Technical Preservation Services
Preservation Assistance Division
National Park Service
U.S. Department of the Interior
Washington, D.C.

Interpreting
the Secretary of the Interior's
Standards for Rehabilitation

4. Revised canopy design met the NPS height condition but introduced potential pedestrian safety problems.

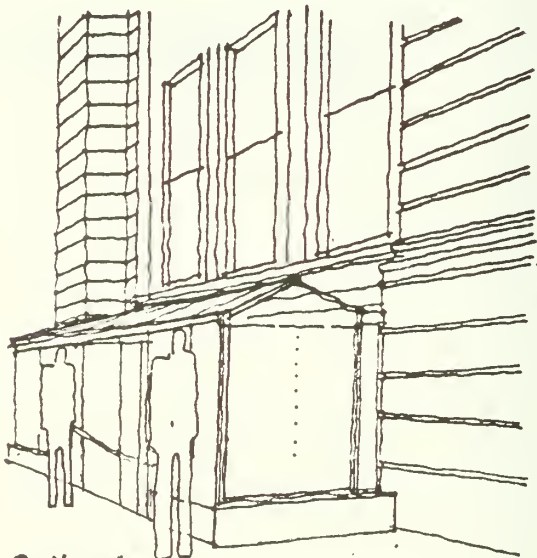
3. Initial canopy design was not approved by NPS because its height obscured the first floor windows.

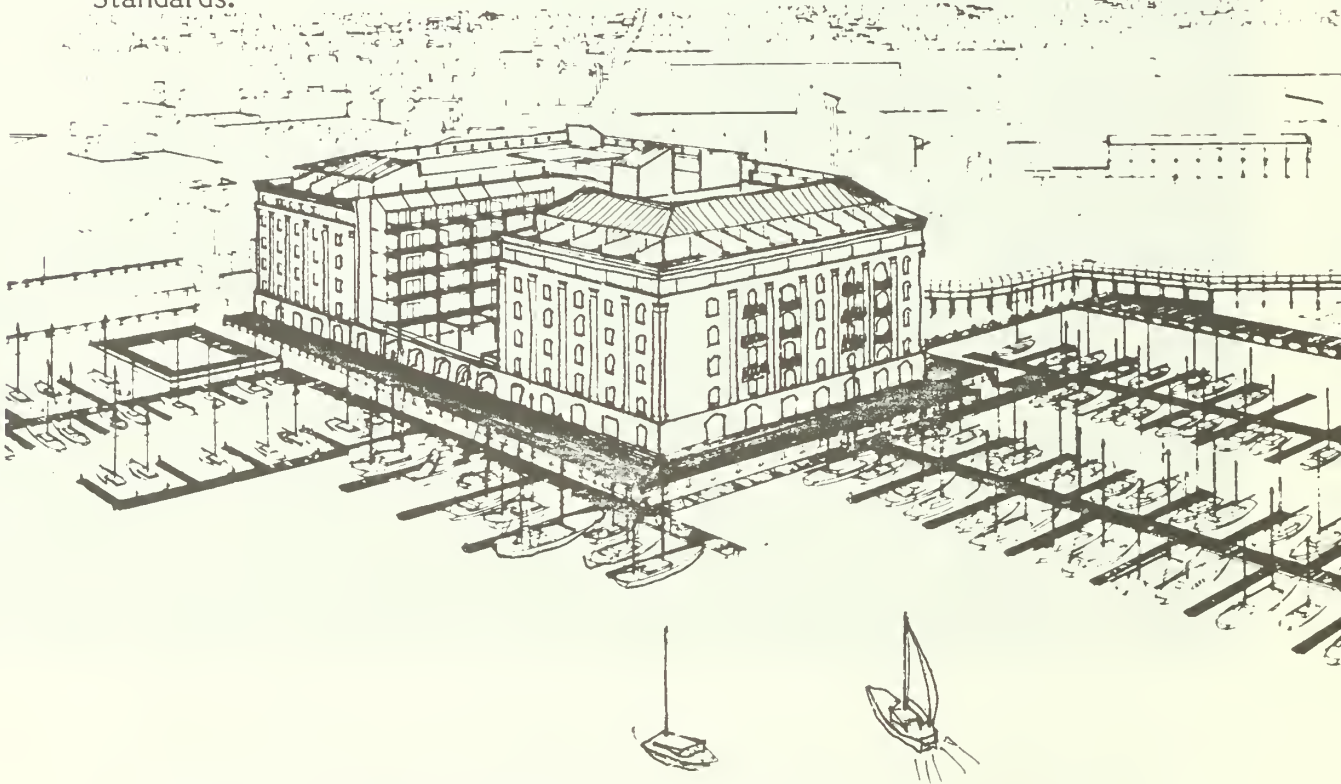
Following an onsite inspection of the warehouse and the district, the hearing officer sustained the denial of the regional office for a number of reasons. He felt that the planar quality of the exterior walls would be drastically altered by the addition of projecting balconies with their inherent shadow lines (see illus. 2). He felt that widening selected bands of windows would interrupt the regular rhythm of the window bays. Widening the upper floor windows would also alter the hierarchy of window openings from large openings on the first floor to the small openings on the top floor. His last major concern was the proposed cut in the building, which not only removed the significant original materials of the facade, but altered the massive quality of the warehouse structure (see illus. 3).

2. The proposed south elevation with bands of projecting balconies. The window openings would be widened or lengthened in order for each of the 204 apartment units to have one balcony. Not only would the windows be altered in selective bands, but the proposed balconies would create deep shadow lines on the facade. While the owner felt that the balconies were a reversible feature that could be removed in the future, the hearing officer determined that both the visual clutter of the balconies and the change in the hierarchy of the window openings did not meet the Standards.

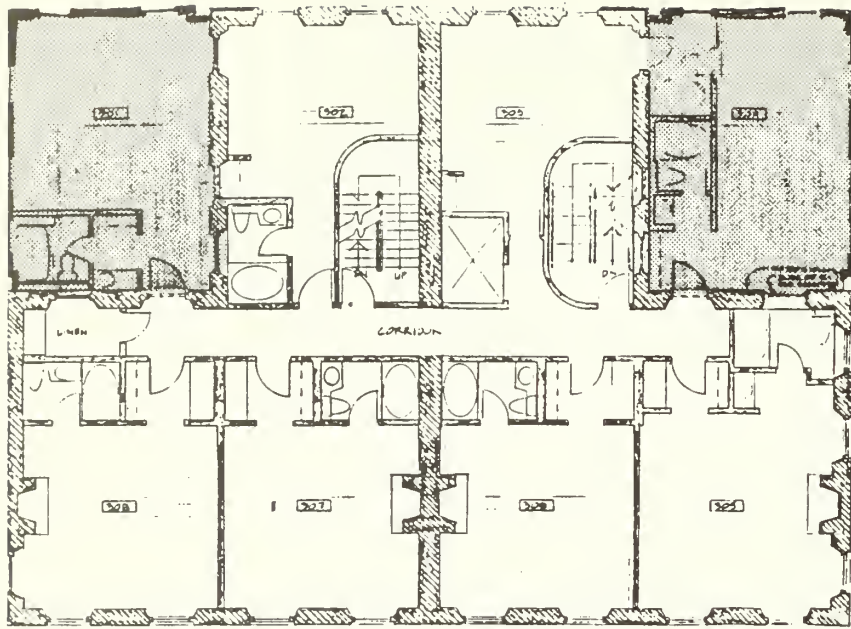
In reviewing the proposal, the regional office agreed with the State on the need to clearly differentiate the new construction from the historic resource through the use of materials and setback connection details, while achieving compatibility in terms of scale, proportion, and location. A modern flush metal panel system was selected for the exterior sheathing of the new construction to act as a neutral backdrop to the carefully restored historic brickwork. The use of glazed panels recessed between the historic masonry and the new addition would allow the distinct feature of the Federal plan to be exposed. In addition, much of the original rear walls of the historic structure would remain exposed with the windows in place as part of the new construction. This would reduce the loss of historic fabric while leaving clear evidence of the connection between the original and new construction (see illus. 3).

Illustration #3. TYPICAL FLOOR PLAN. The proposed infill plan (shaded) would respect the historic materials by leaving the original rear walls exposed within the new addition. The existing window and door openings would be left in place, as much as possible. In addition, recessed panels would be used as a connector infill between the original building and the additions in order to clearly differentiate the new construction from the historic structure.

Illustration #4. ELEVATION

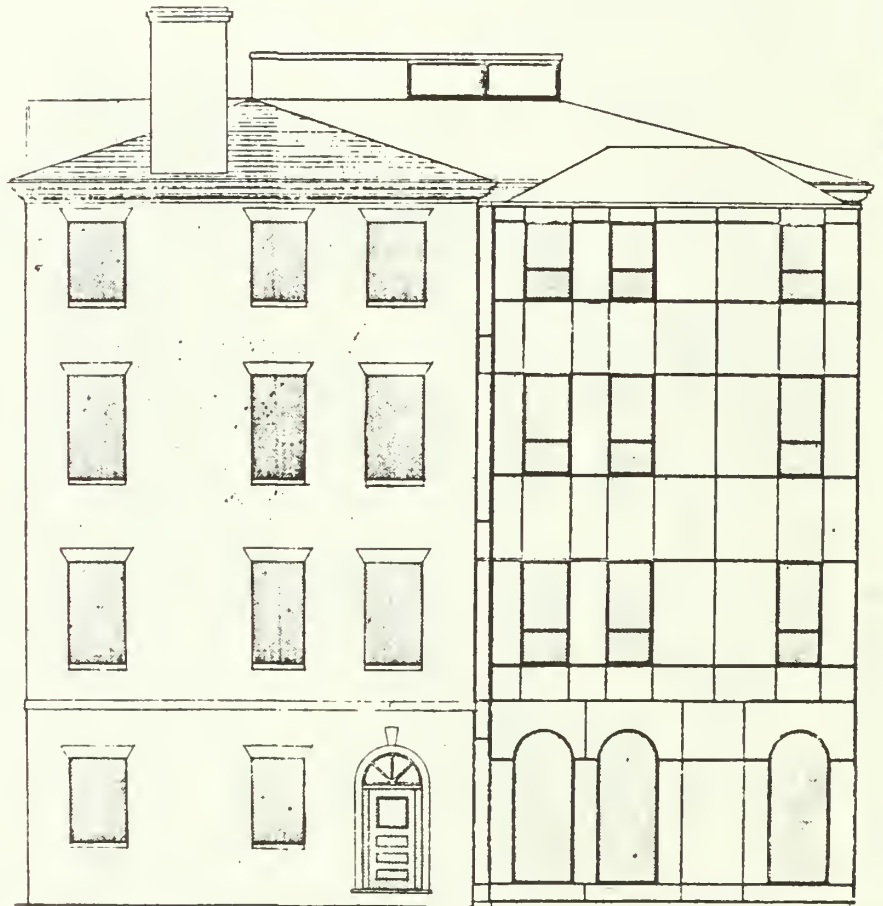
The new 4 story addition visible from the street would be compatible in scale and proportion with the historic structure. The pattern of window and door openings in the new addition would reflect the rhythm in the historic facade. The use of a modern panel system, as opposed to detailed brickwork, would clearly separate the new construction from the historic resource. The use of a separate hipped roof for the addition would retain the scale of the property and would eliminate damage to the historic roof and cornice.

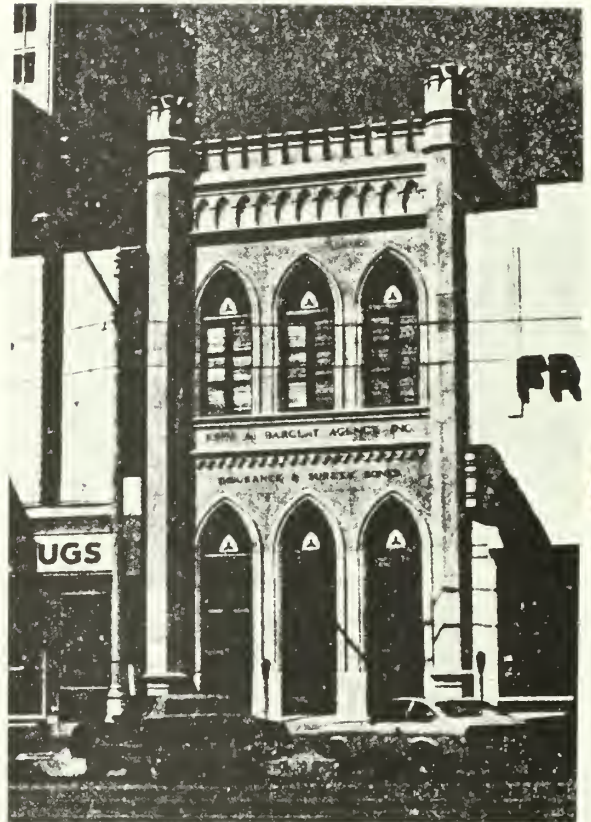
4. This photograph shows a totally reconstructed facade using all new material. NPS recommended denial of the project for tax benefits because it was determined that the damaged upper level could have been repaired. An unacceptable loss of historic material on a significant facade was specifically mentioned in the denial letter.

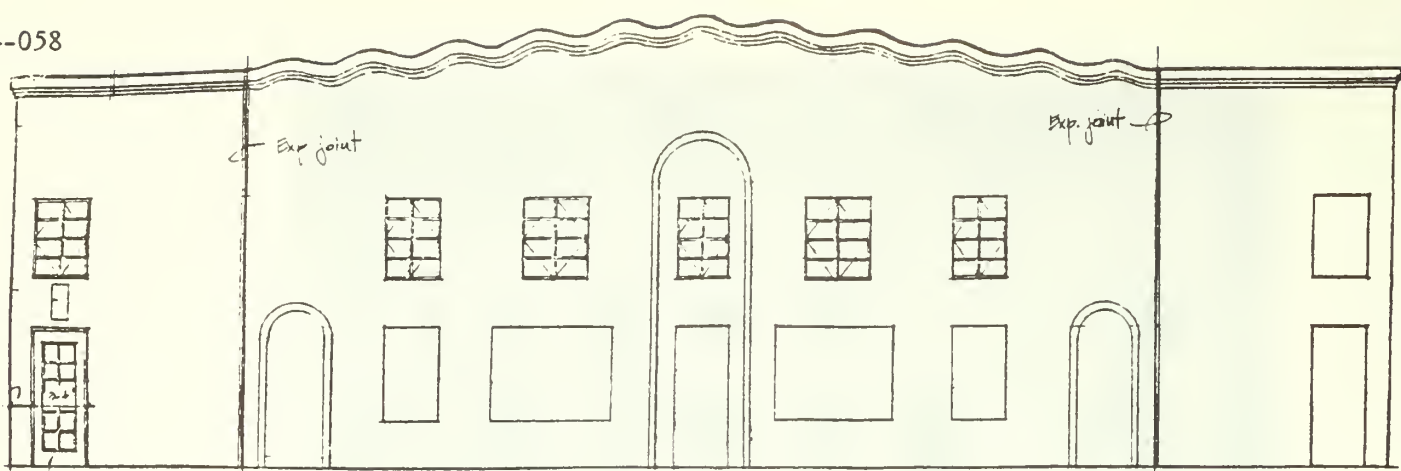
3. This view of the northeast corner of the primary elevation shows the added wing wall that was built to visually balance the new addition on the southeast corner. Again, the addition extends from the end of the historic building, as defined by the waved parapet cap. Both additions increased the total length of the historic building by one-third and made indistinguishable what was historic and what was new construction.

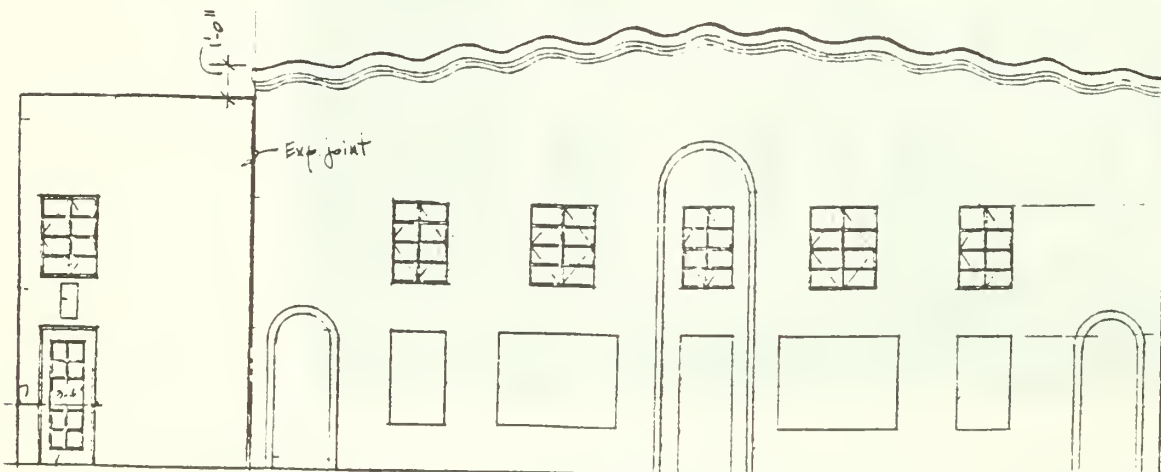
5. Scheme "B" was also offered by the developer as a means of making the project meet the Standards. Part of this design change was acceptable--the lowered parapet on the stair enclosure. The total scheme was rejected, however, because the nonfunctional northeast wing wall, even though differentiated in height, still unnecessarily expanded the historic form of the building. It also created a symmetry at a scale that never existed historically.

6. Scheme "C" represents those changes to the design that would have to be made to bring the project into conformance with the Standards. The Chief Appeals Officer specifically listed as requirements for certification a widened expansion joint; demolition of the northeast corner wing wall; lowering the parapet on the stair tower; and further distinguishing the new addition from the historic facade by use of a different paint color.

The only remedial action that can now be taken...would be to follow scheme "C": insert a wide expansion joint between the historic building facade and the new stair enclosure, demolish the new wing wall, lower the parapet on the stair tower by at least one foot, and paint the new addition a different color than the original facade. These actions would make the distinction between the old

and new construction clear; and would restore to the building its aspect of a modest, simplified Spanish Colonial Revival commercial structure. Demolition of the wing wall would allow one to view the continuous wavy cornice as it carries around the corner. If the final revised project fails to meet any of the above conditions, it will not meet the Standards and cannot be certified.

3. Section showing proposed insertion of two floors and a hallway within the sanctuary.

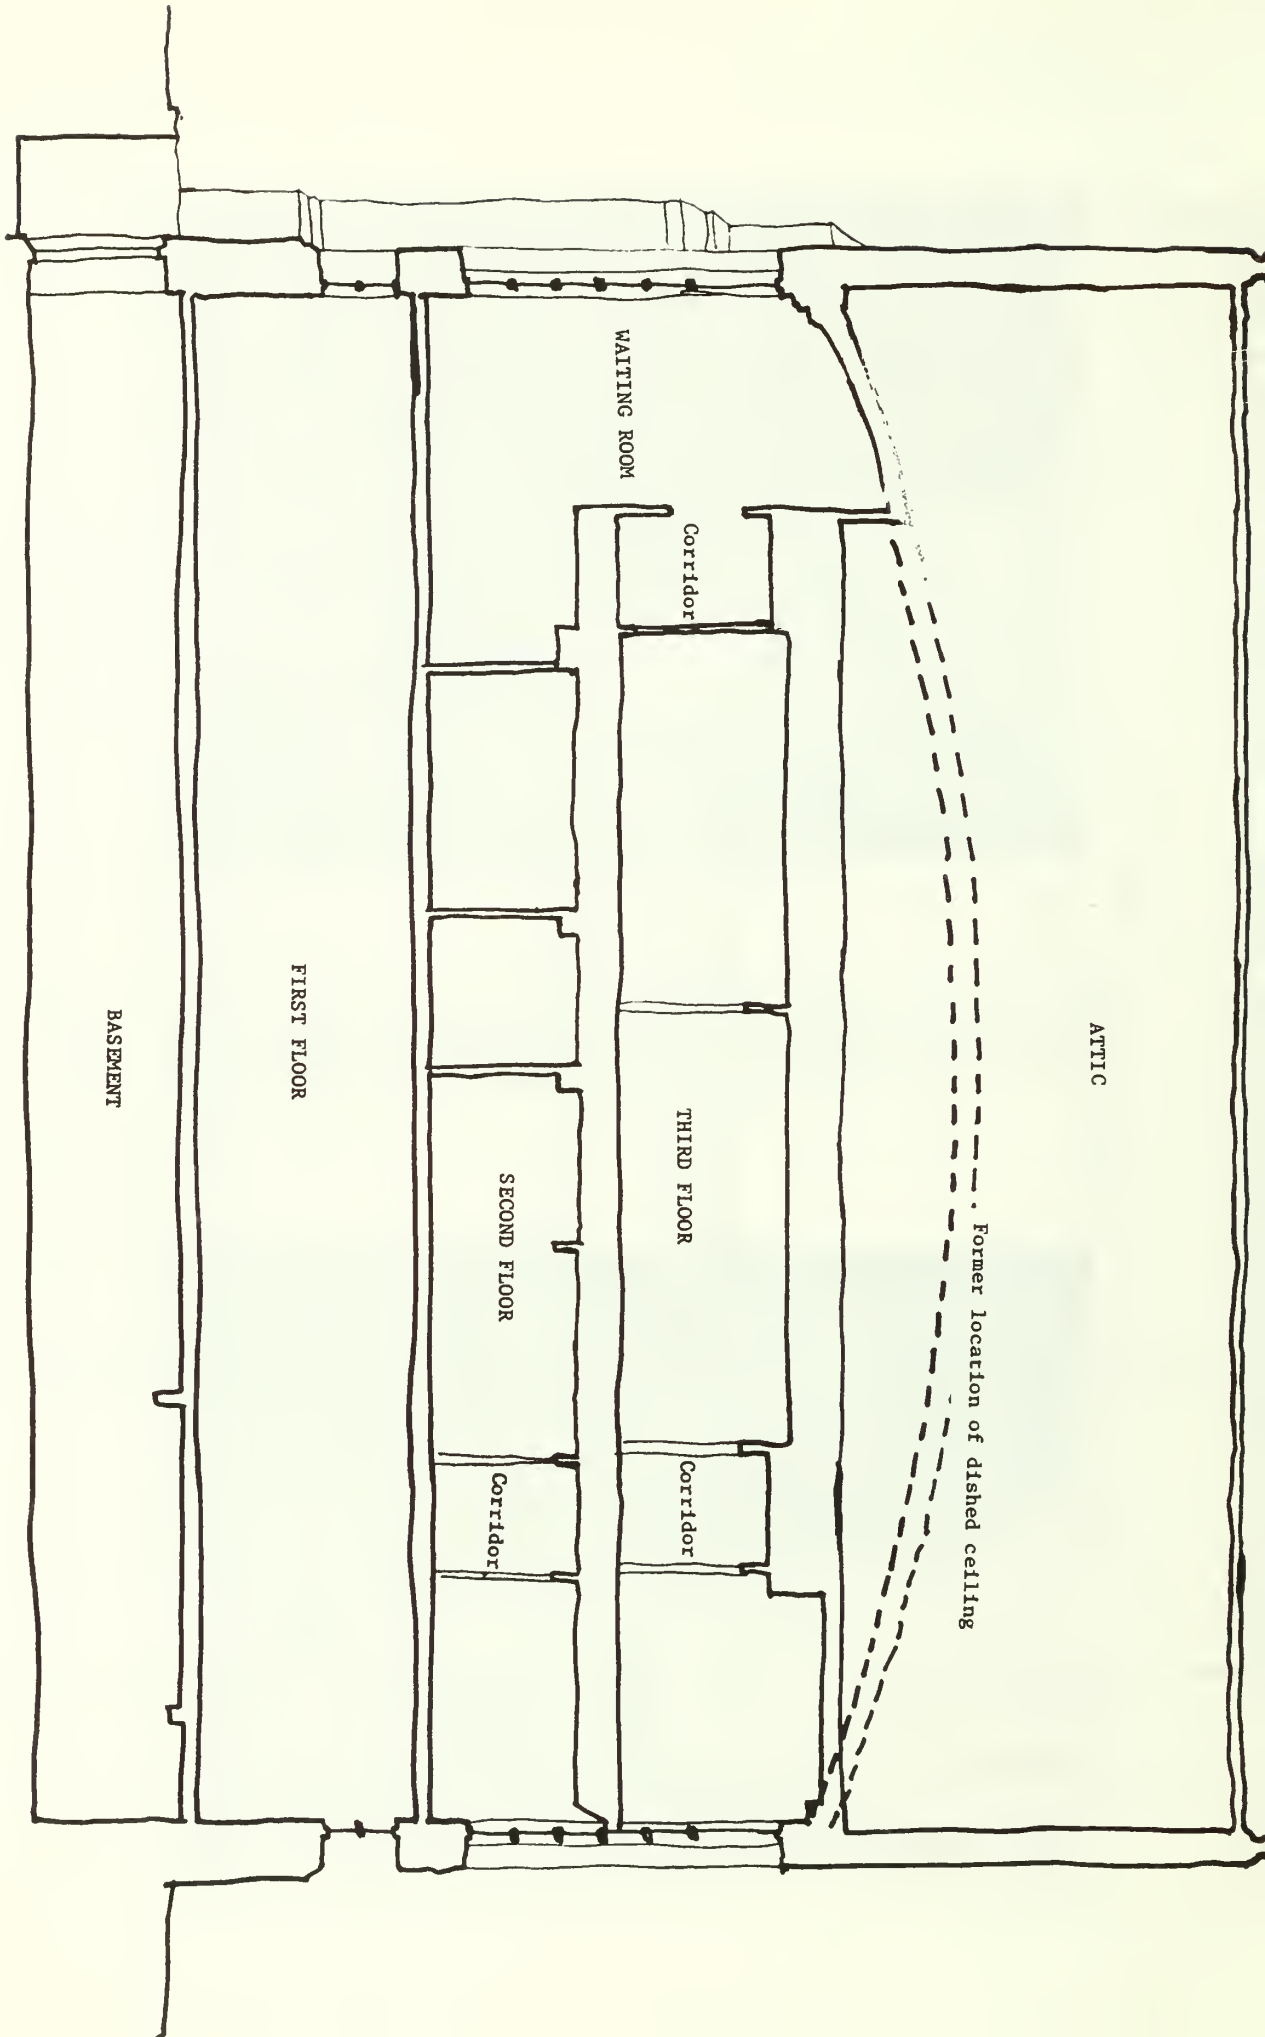
4. Section of Octagon sanctuary space with proposal to add floors and partitions for the new use as offices. Two-story waiting room with reconstructed plaster details on left of sketch.
